REVISION LOG	
REVISION:001	DATE: 10-19-23
1. MOVED THE FRONT KNEEWALL INSIDE 1'-0" REDUCING THE SQUARE FOOTAGE. SQUARE FOOTAGE REVISED.	
REVISION:002	DATE: 9-10-24
1. MADE WALK THROUGH REVISIONS 2. ADD ELECTRICAL PLANS	
REVISION:003	DATE: 03-25-25
1. ADD GOURMET KITCHEN OPTION 2. ADD SIDE LOAD GARAGE OPTION

Add dimensions to front of foundation on S1a to allow for brick at the front porch.- JJ - May -14-2025

Lot 195 - Ballard Road

# The Guilford Georgian - LH

FIRST FLOOR PLAN - GEORGIAN  
SCALE: 1/4" = 1'-0" ON 22x34, 1/8" = 1'-0" ON 11x17

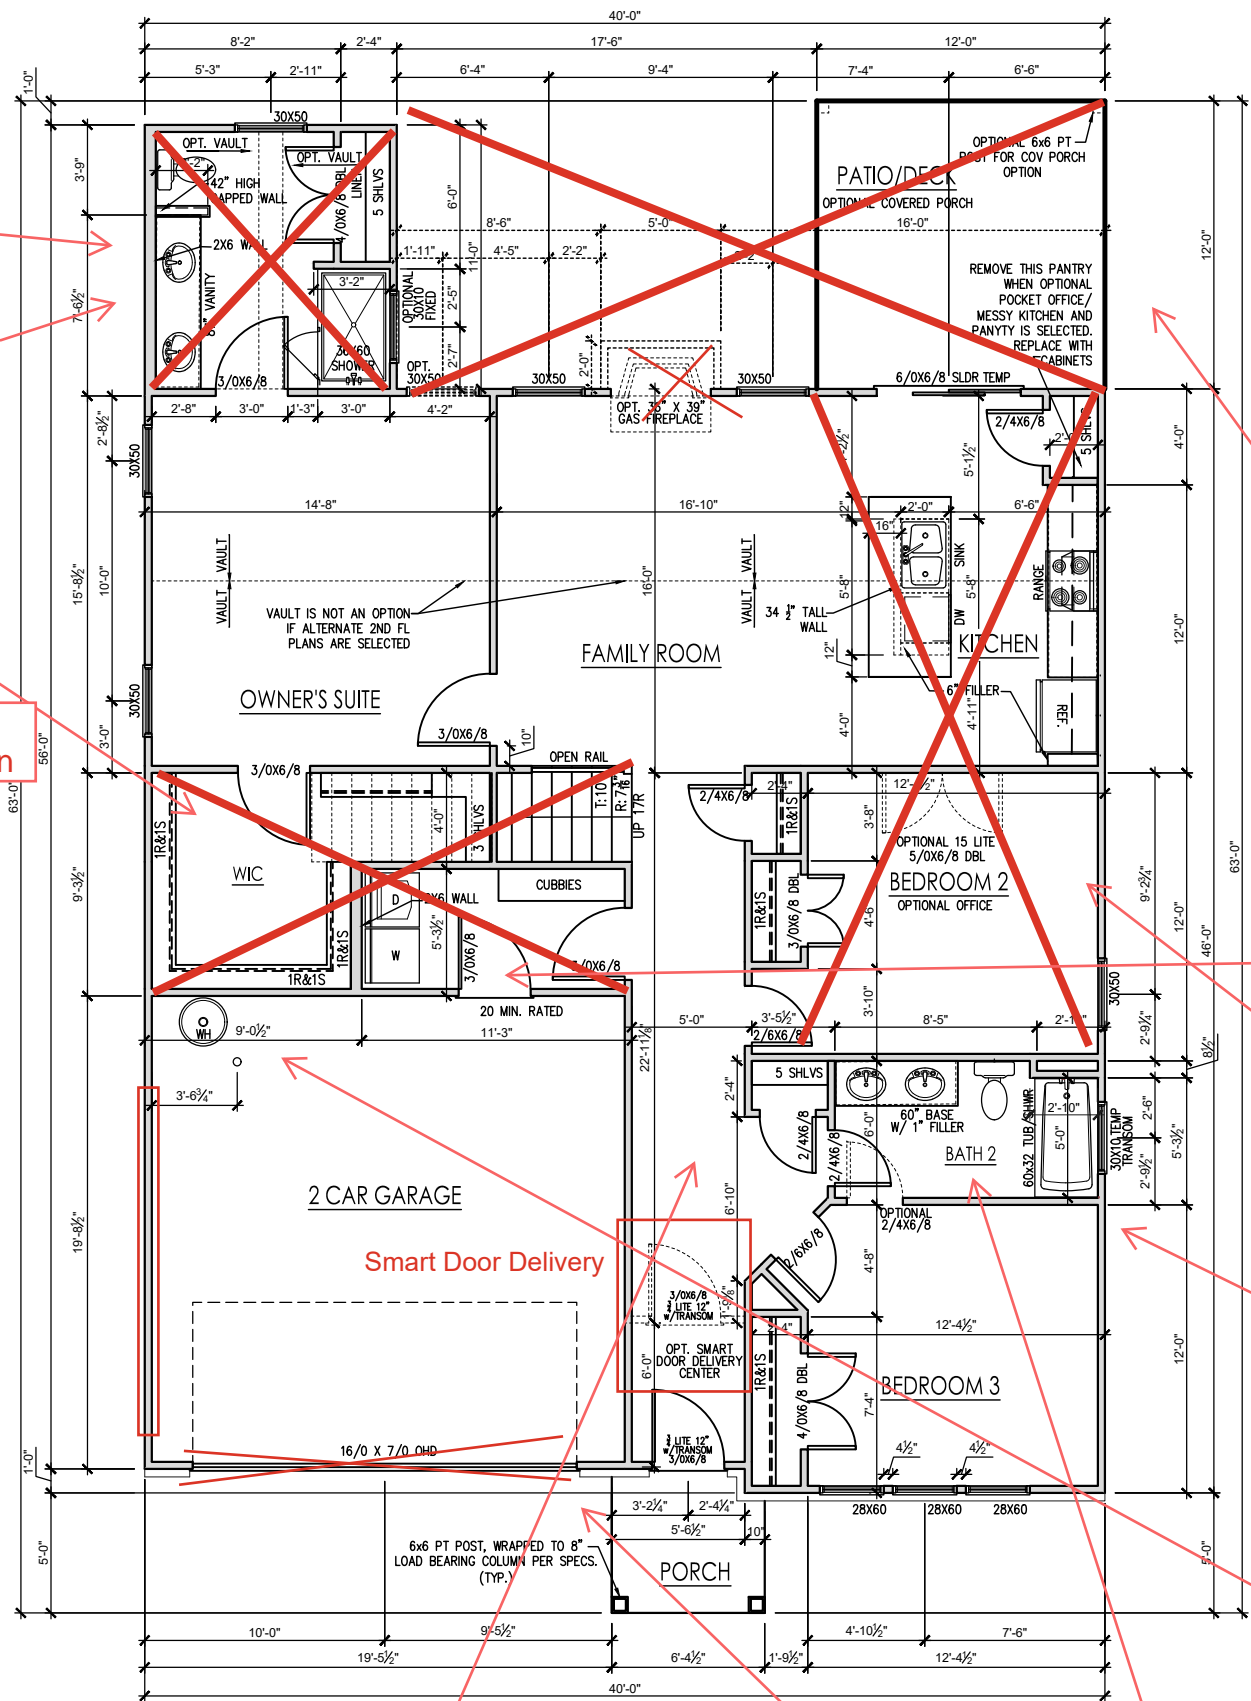
DO NOT INSTALL  
ACCESSORIES

Tile shower pan  
ILO fiberglass pan

LVP FLOOR ILO  
TILE

Shower ILO Tub/  
Shower

tankless hot water  
heater

OWNER'S SUITE BATH  
W/ SHOWER W/ SEAT OPTION  
SCALE: 1/4" = 1'-0" ON 22x34, 1/8" = 1'-0" ON 11x17

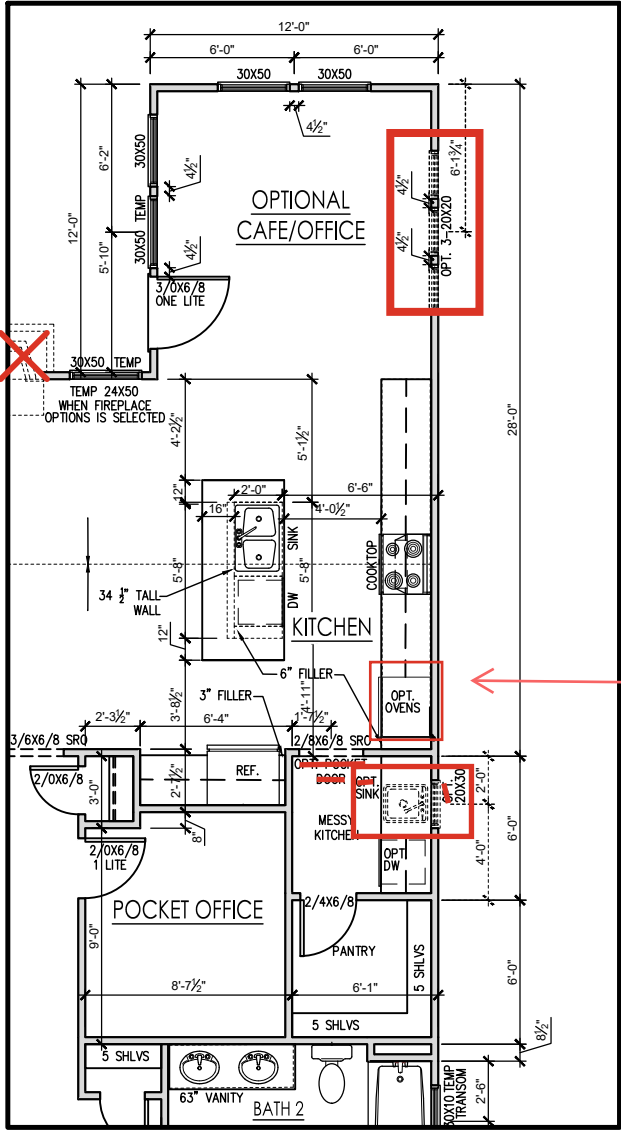
DO NOT INSTALL  
ACCESSORIES

MATTE BLACK  
HARDWARE  
INSTALLED

SHEET NO.  
S1A

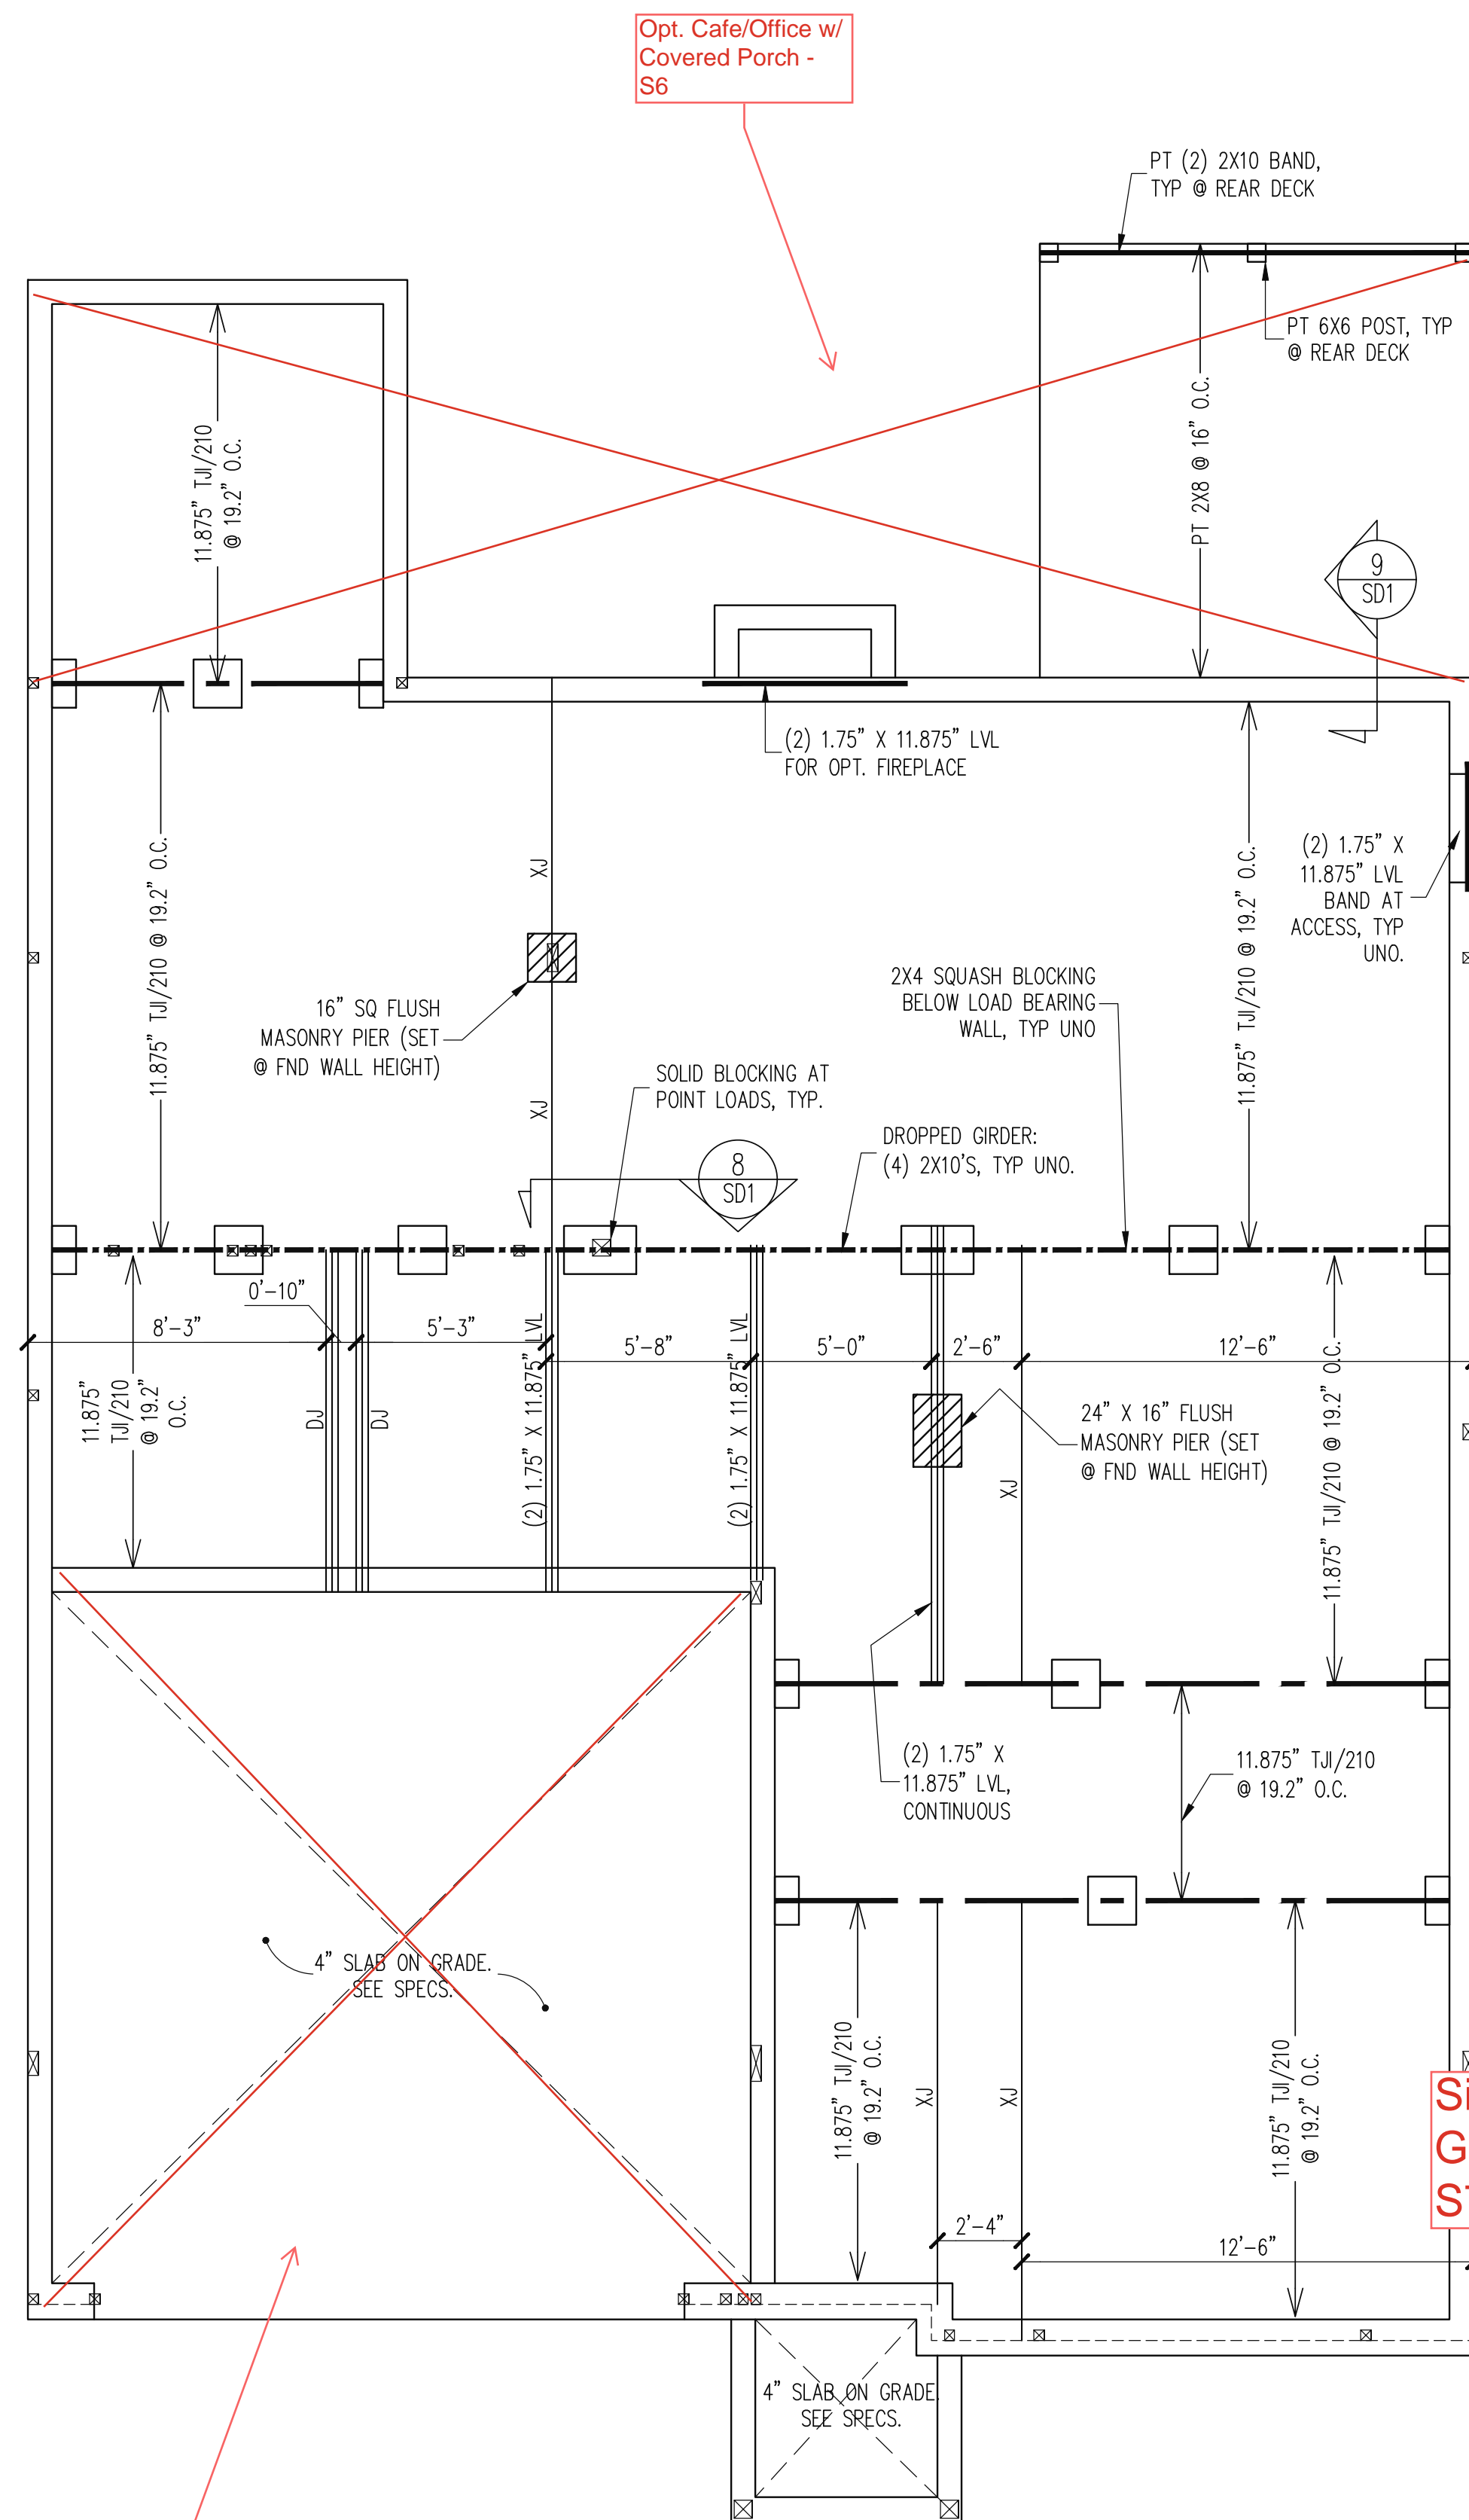
63'-5" to allow  
for brick at the  
front porch
